Addendum 04 for RFB947500-01

Project Name: CHMHI Fleet Garage Repairs
DAS RFB#: 947500-001
DAS Project #: 9475.00
Date: 11/19/25

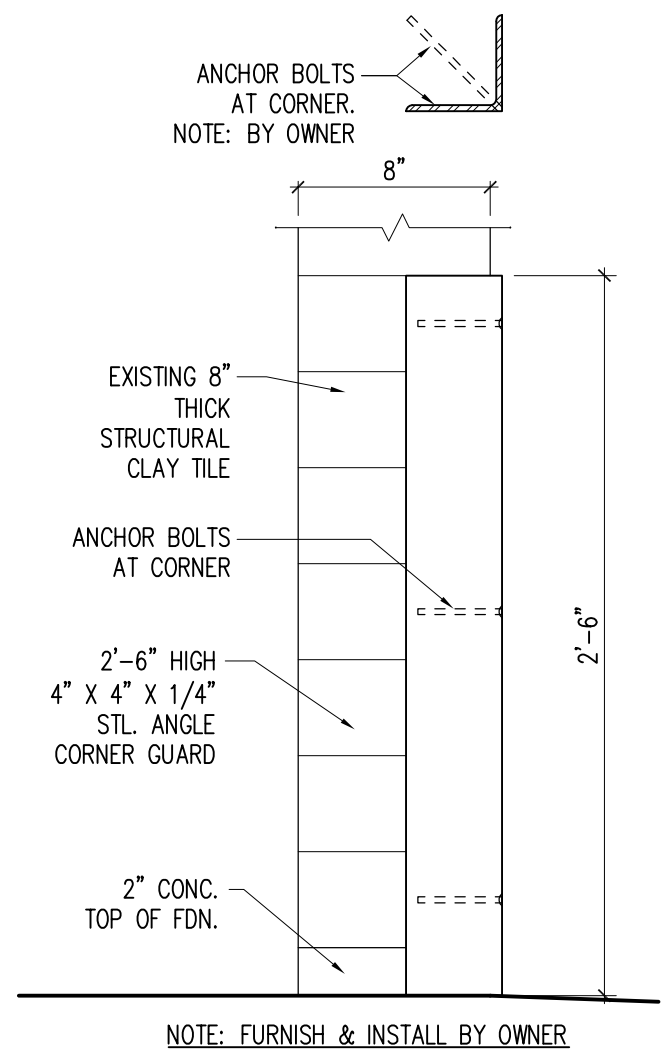
- Are they 7' wide by 8' tall or are they 8' wide by 7' tall?
 - All overhead doors are 8'0" w x 7'0" h. See plan widths and section height. Change on door schedule for doors 104 through 115

DOOR SCHEDULE			H.M. DOOR	O.H. DOOR	OPEN ONLY	FRAME	LINTEL
101	HM DOOR & FRAME	3'-0" X 7'-0" X 1 3/4"	●			4/A2.1	2/A2.1
102	EXISTING OPENING	3'-0" X 6'-8" M.O.			●	EX WD.	2/A2.1
103	HM DOOR & FRAME	3'-0" X 7'-0" X 1 3/4"	●			4/A2.1	2/A2.1
104	OVERHEAD DOOR	7'-0" X 8'-0" 8'0" W x 7'0" H		●		5/A2.1	EX WD.
105	OVERHEAD DOOR	7'-0" X 8'-0" 8'0" W x 7'0" H		●		5/A2.1	EX WD.
106	OVERHEAD DOOR	7'-0" X 8'-0" 8'0" W x 7'0" H		●		5/A2.1	EX WD.
107	OVERHEAD DOOR	7'-0" X 8'-0" 8'0" W x 7'0" H		●		5/A2.1	EX WD.
108	OVERHEAD DOOR	7'-0" X 8'-0" 8'0" W x 7'0" H		●		5/A2.1	EX WD.
109	OVERHEAD DOOR	7'-0" X 8'-0" 8'0" W x 7'0" H		●		5/A2.1	EX WD.
110	OVERHEAD DOOR	7'-0" X 8'-0" 8'0" W x 7'0" H		●		5/A2.1	EX WD.
111	OVERHEAD DOOR	7'-0" X 8'-0" 8'0" W x 7'0" H		●		5/A2.1	EX WD.
112	OVERHEAD DOOR	7'-0" X 8'-0" 8'0" W x 7'0" H		●		5/A2.1	EX WD.
113	OVERHEAD DOOR	7'-0" X 8'-0" 8'0" W x 7'0" H		●		5/A2.1	EX WD.
114	OVERHEAD DOOR	7'-0" X 8'-0" 8'0" W x 7'0" H		●		5/A2.1	EX WD.

115	OVERHEAD DOOR	7'-0" X 8'-0" 8'0" W x 7'0" H		●		5/A2.1	EX WD.
